**TOWN OF CARMEL**  
**PLANNING BOARD**

**PLANNING BOARD AGENDA**  
**APRIL 14, 2022 – 7:00 P.M.**

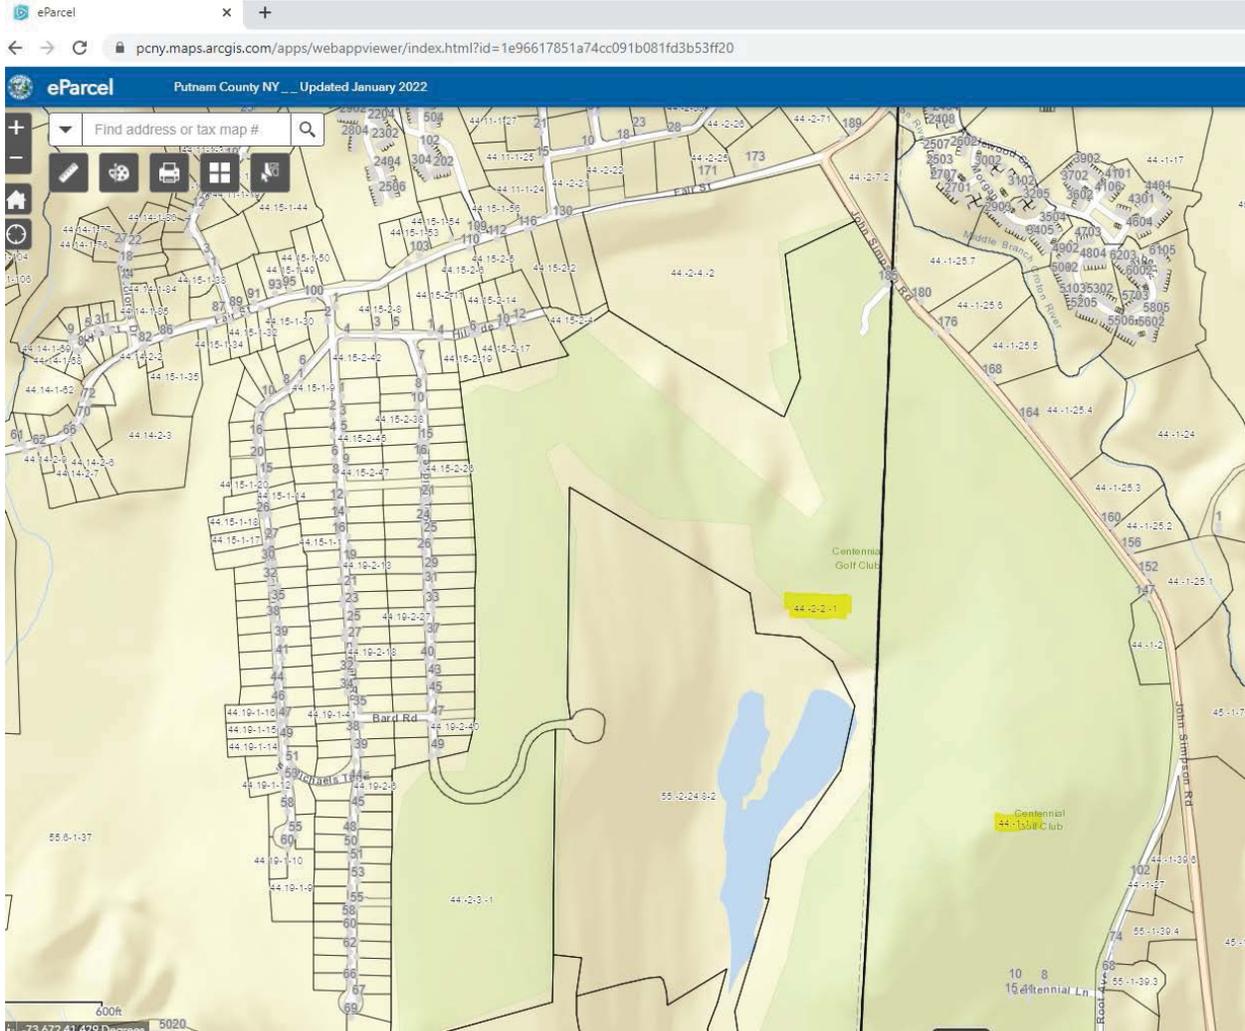
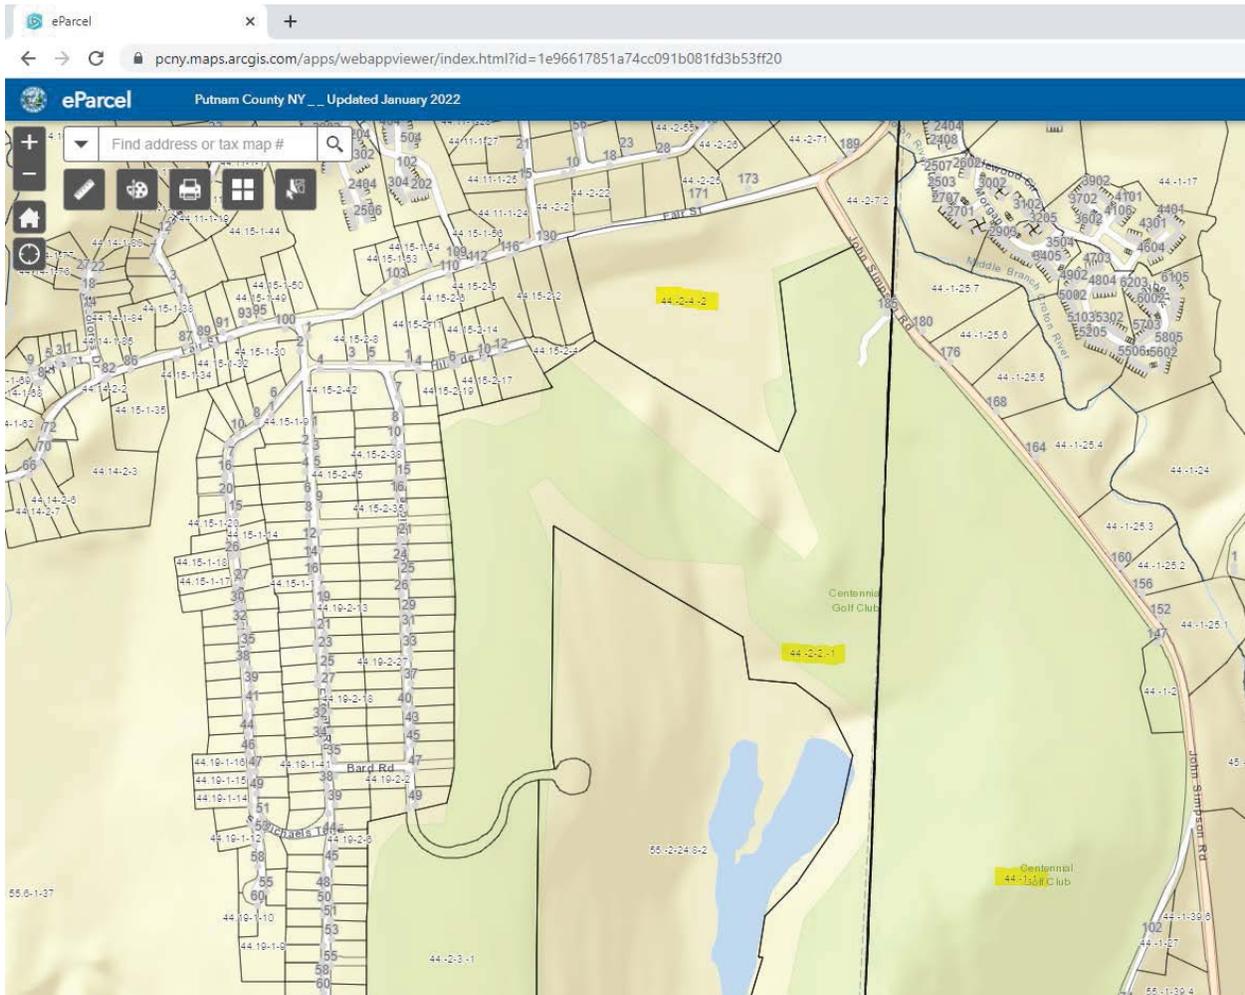
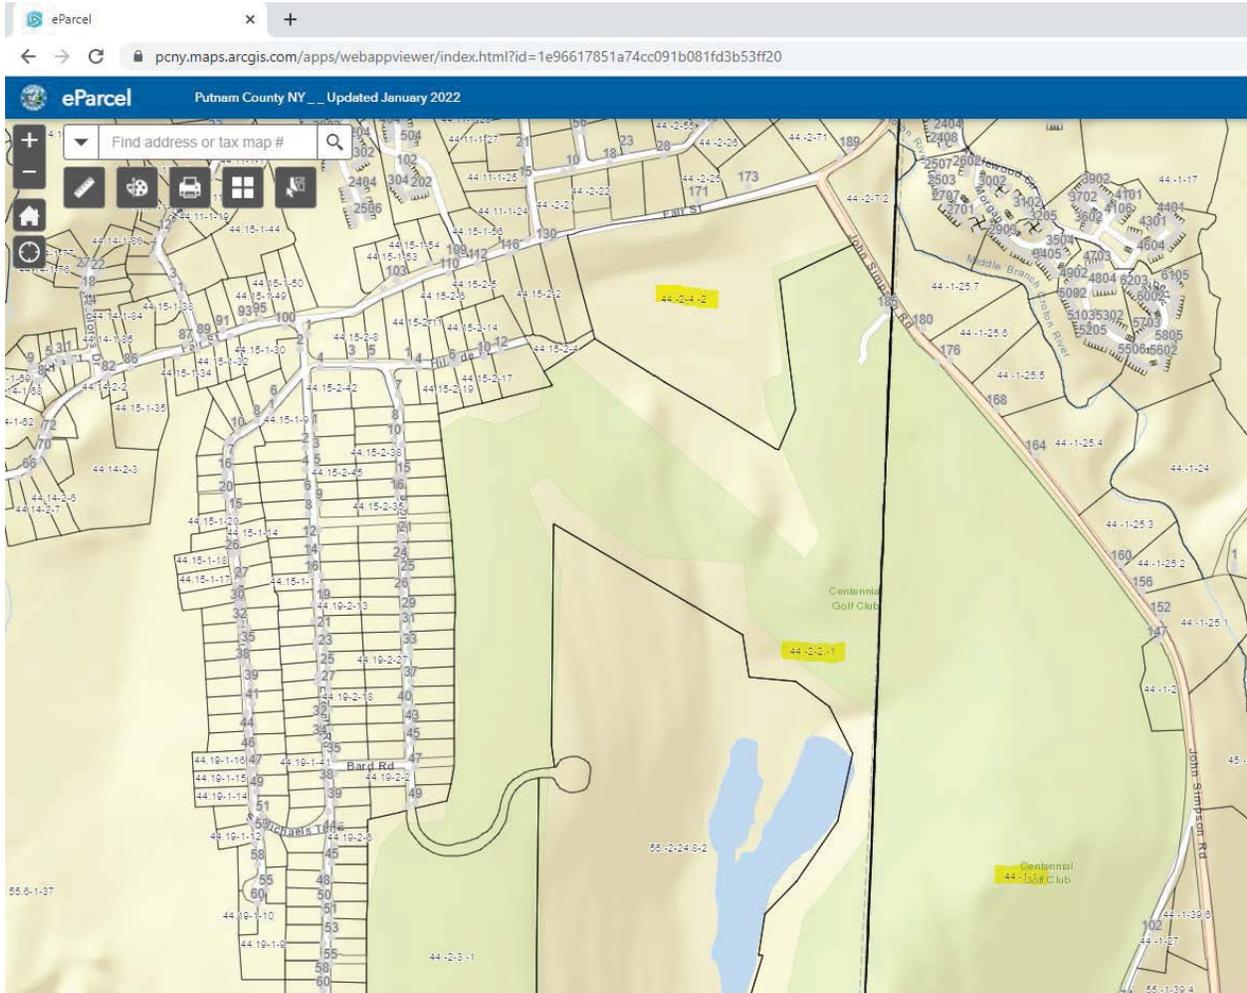
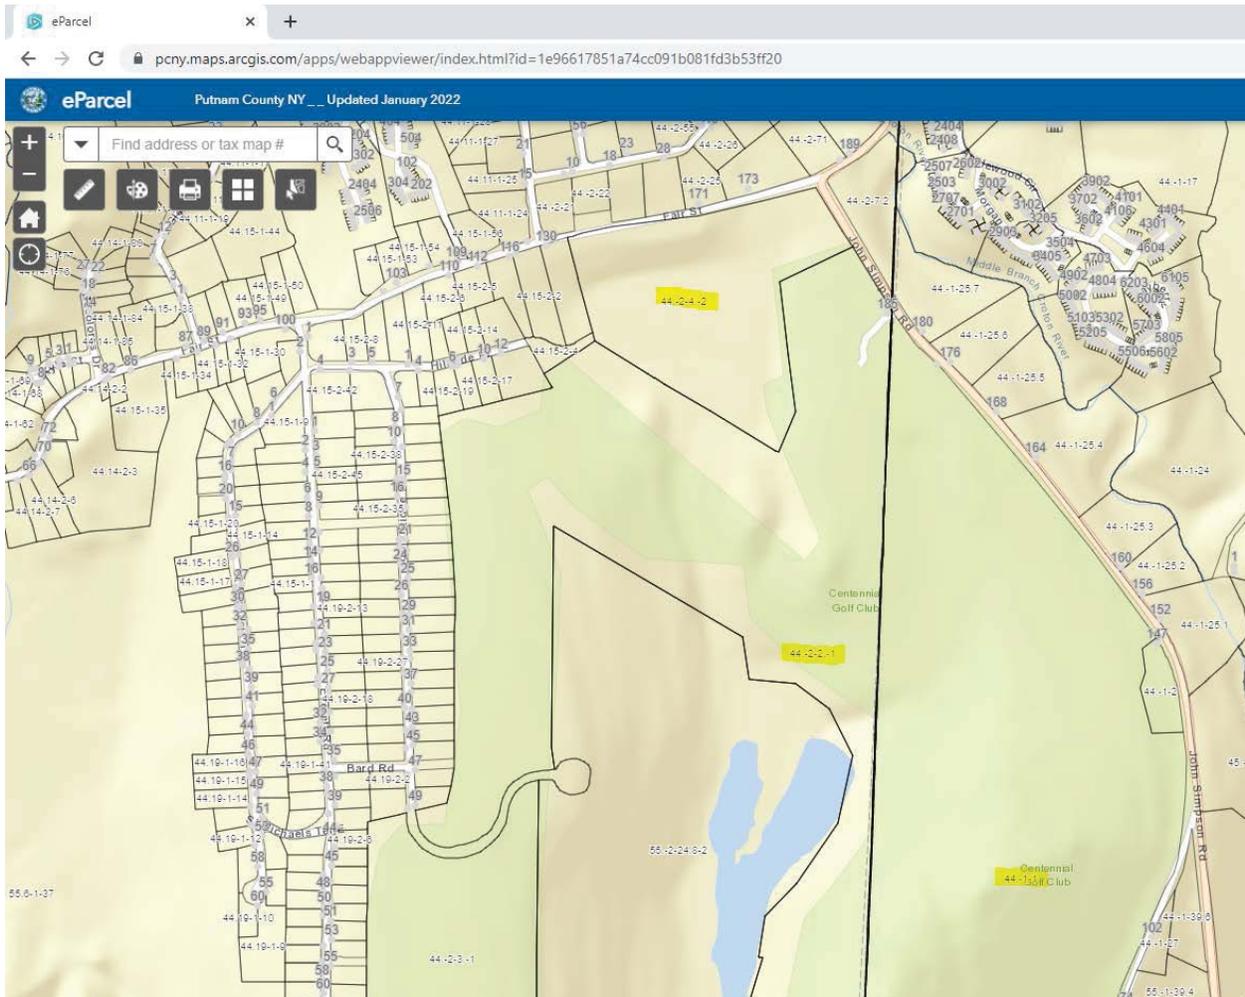
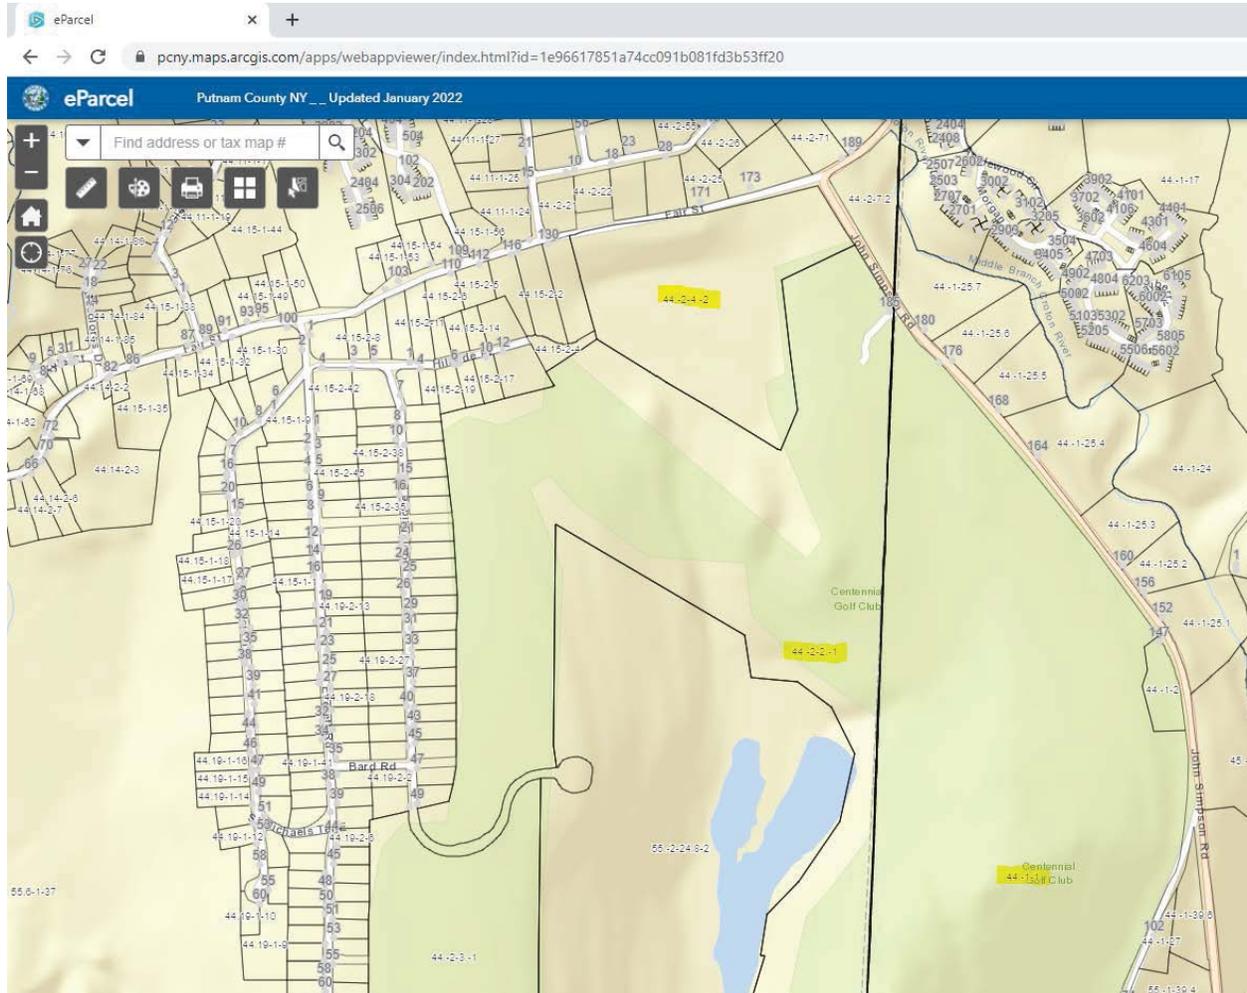
Why is the narrative for the Townhouses included in the application for the golf course? Very confusing.

Provide a recreation calculation table. 300 s.f./dwelling unit are required

The larger lot is labeled 44.2-2.1, that is incorrect, it is 44.- 2-2.2.

Before anything is referred to the ZBA, all tax I.D. #'s need to be corrected on the plat and verified.

***Response: There is now a table on sheet C130 that includes a calculation for recreation space.***

**Response:** All Tax I.D. #'s were found via the Putnam County GIS application (updated January 2022). Refer to the snip below. All Tax I.D. #'s have been updated.

*Response: All Tax I.D. #'s were found via the Putnam County GIS application (updated January 2022). Refer to the snip below. All Tax I.D. #'s have been updated.*
